Site Instruction

SI 26

PROJECT : Hampton Manor
PROJECT No : 1136.13
DATE : October 10, 2018

Title: Addition of Roof Scuppers

ROYAL PINES HOMES

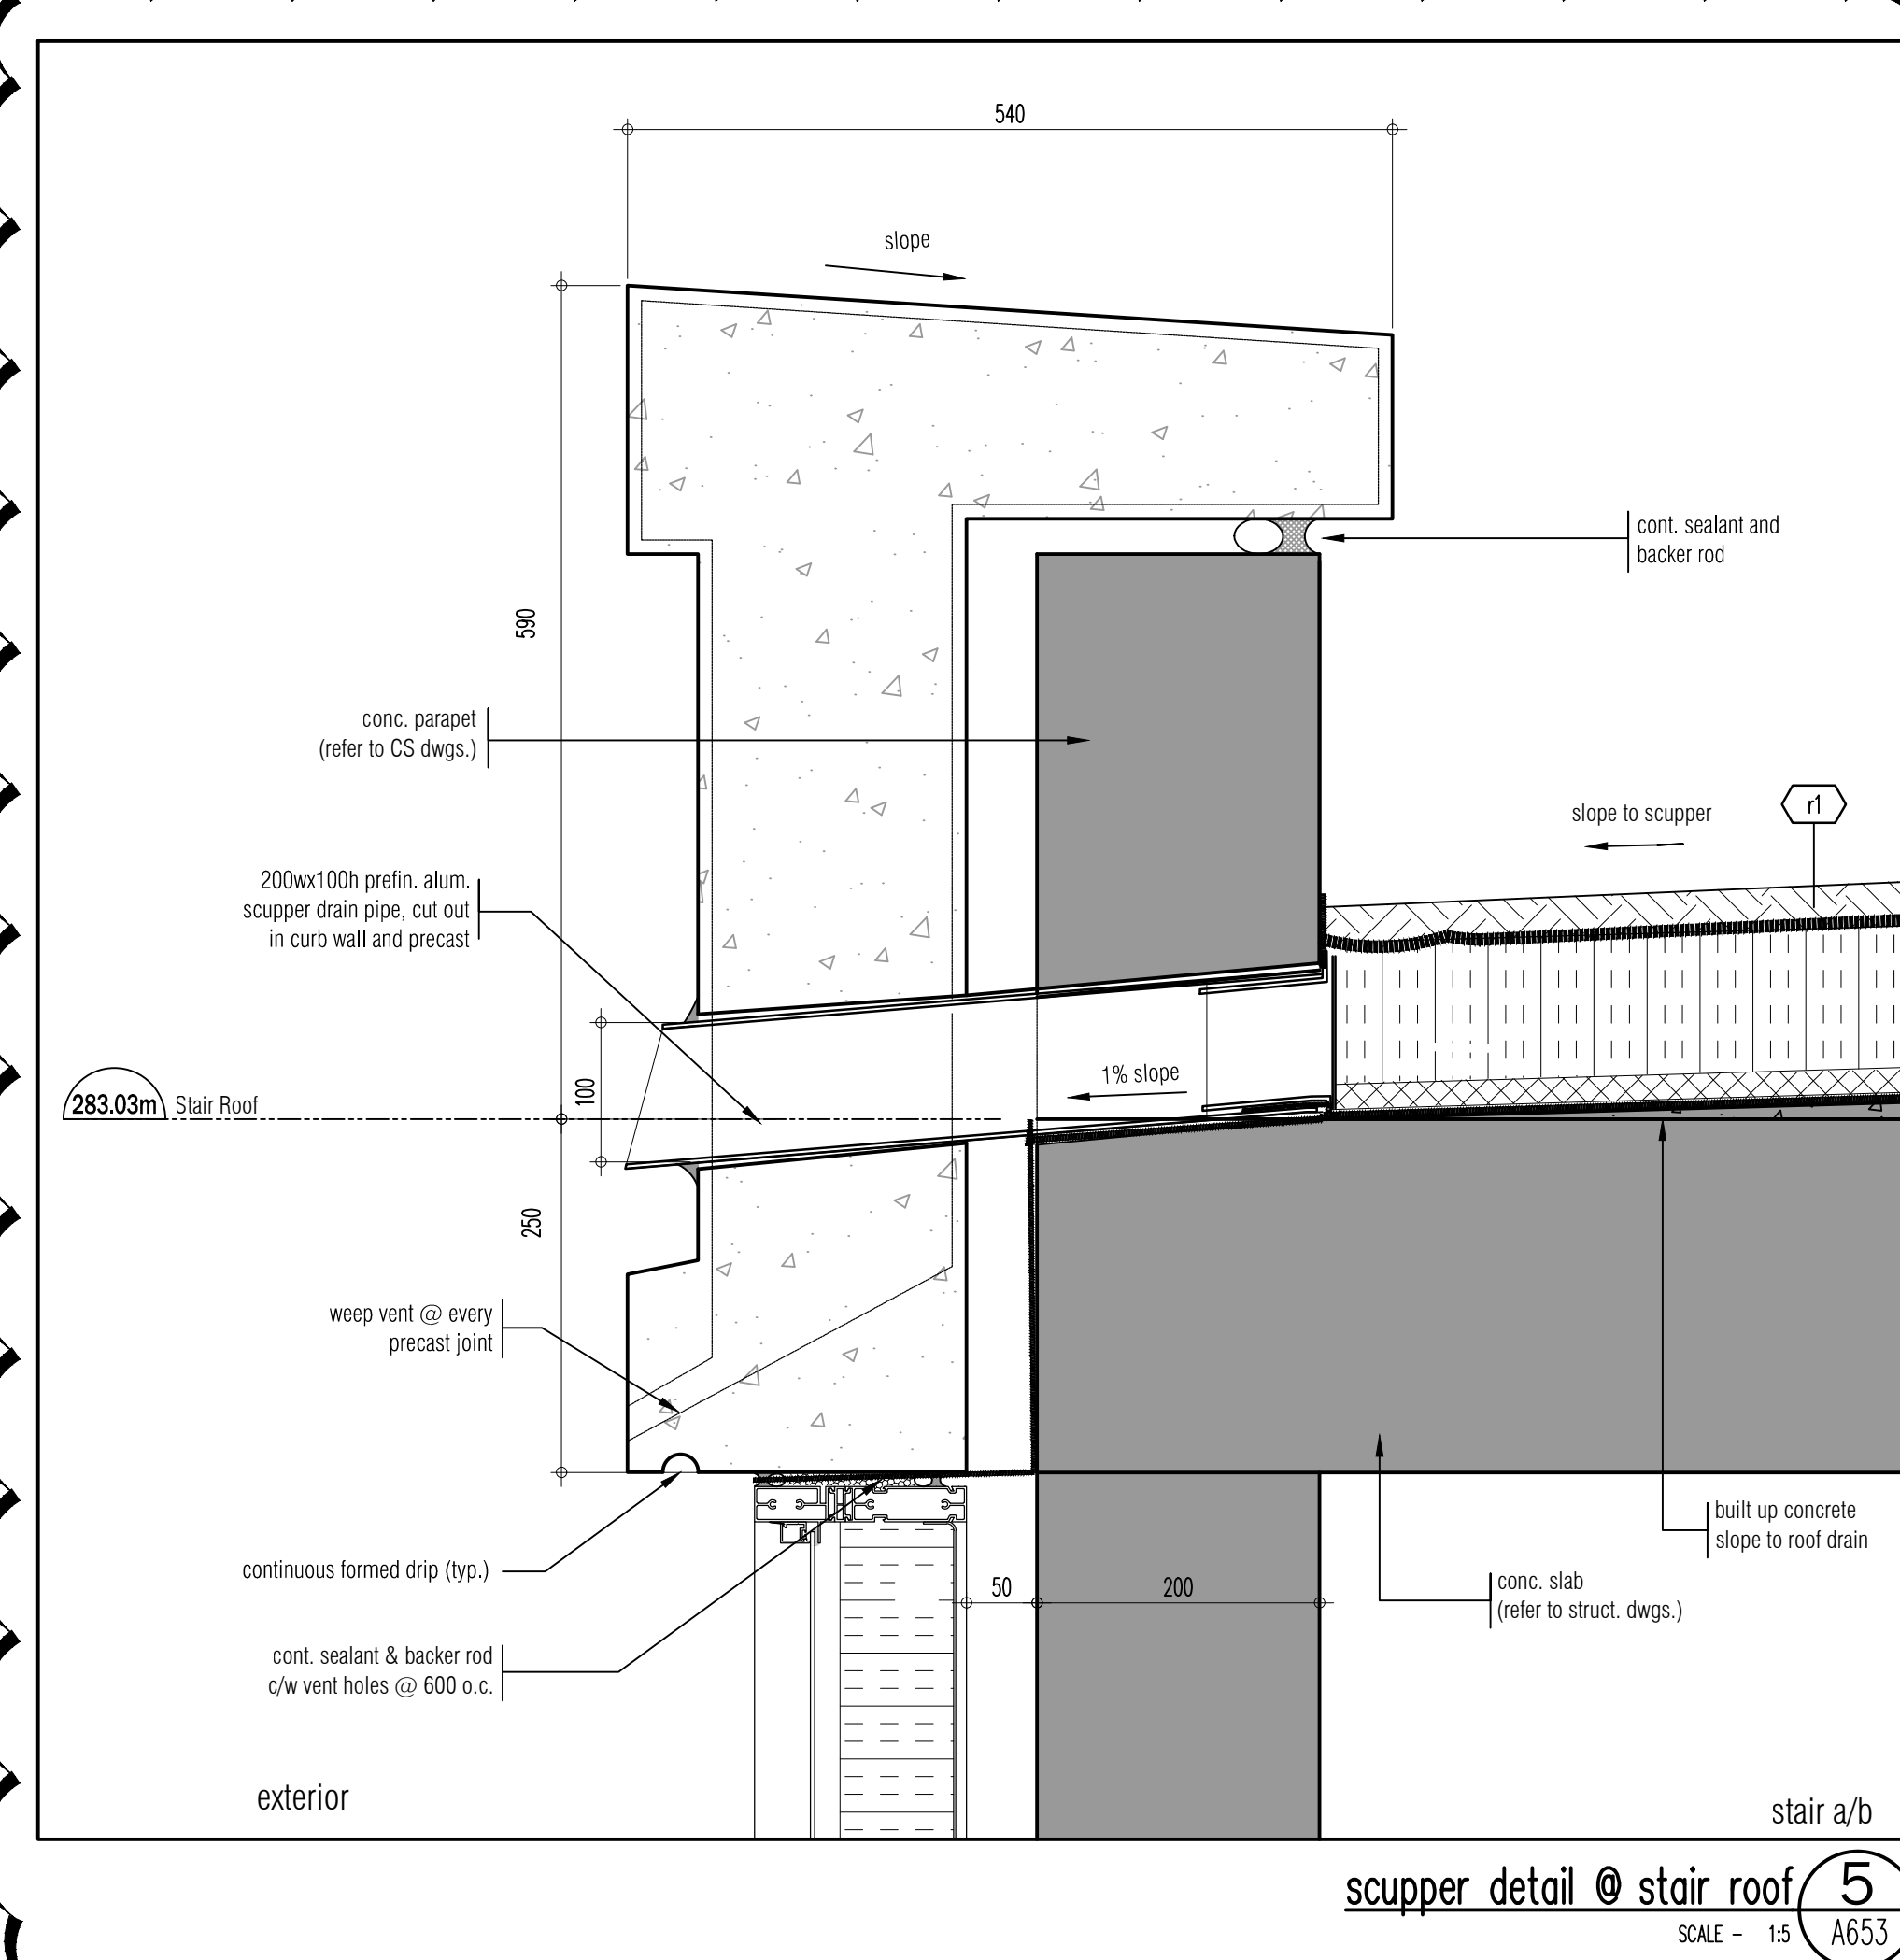
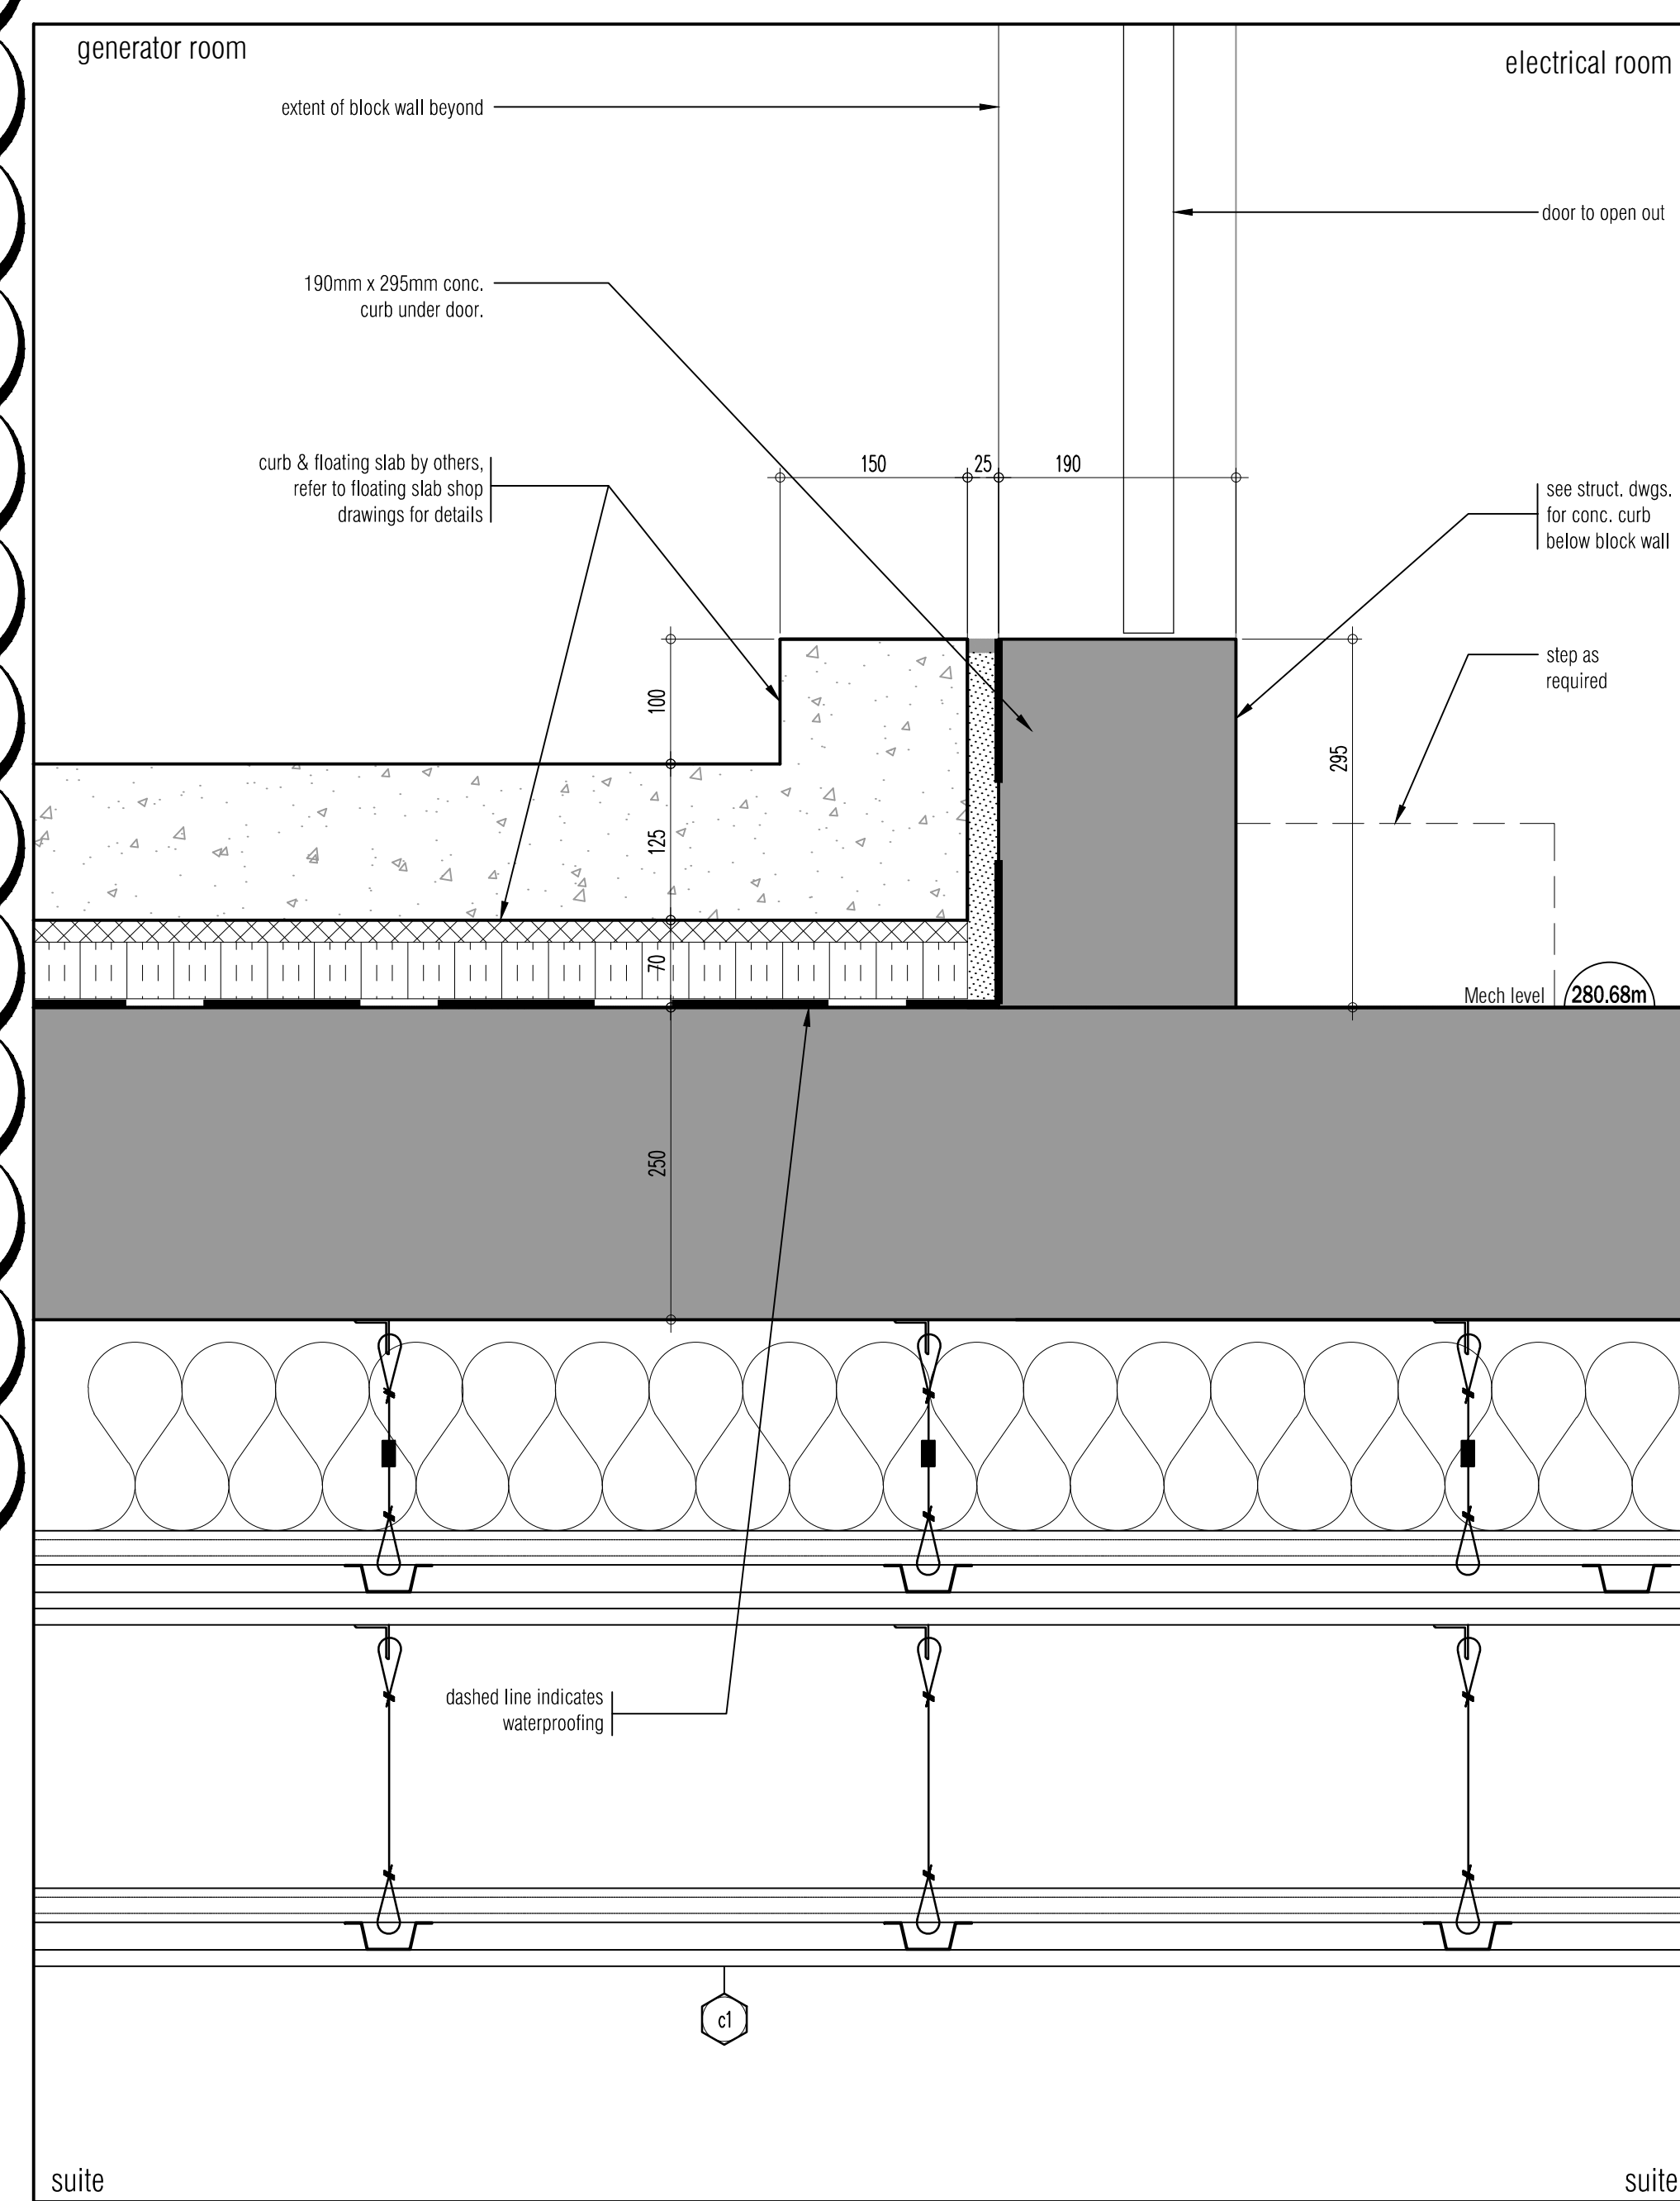
A401a-A401c – Building Elevations

- Adding Scuppers to Roof curbs
